# Summary of Comments on 1801-222-SUB1- PLANS\_review.pdf

**Project:**  
 TALERMAN SIMON RESIDENCE  
 387 WEST MERZER WAY  
 MERZER ISLAND, WI 53840

**Sheet Title:**  
 CIVIL SITEWORK PLAN

**Sheet No:**  
**C1.1**

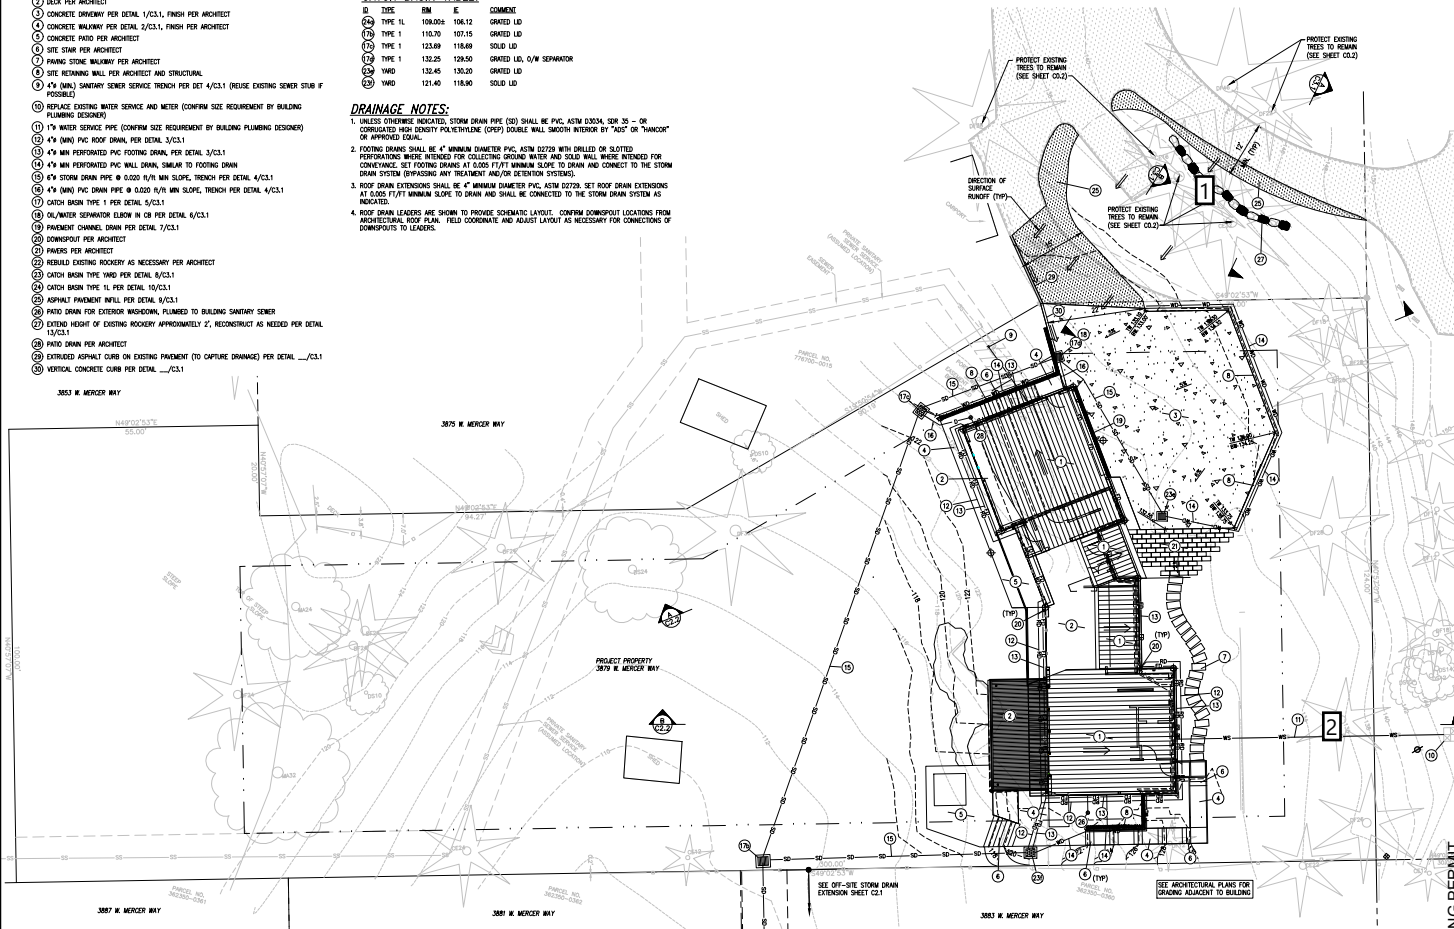
Number: 1      Author: Tree Review (john.kenney@mercergov.org)      Subject: Sticky Note      Date: 11/13/2018 8:11:10 AM  
2. All replacement trees to be at least 10' apart from each other, existing trees and structures. Please call out.

1. Trees on adjacent property are not included in the Arborist report. Arborist needs to provide information on these trees including proposed tree for removal. Minimum limits of disturbance for these trees need to be provided. Arborist needs to review and comment on current plans and new driveway expansion and rock wall.  
Civil sheet needs to be updated with Arborist provided tree numbers.

3. Tunnel/bore WS line within dripline of saved tree (trees to be numbered on this sheet). Call this out. Or move WS line outside saved trees dripline.
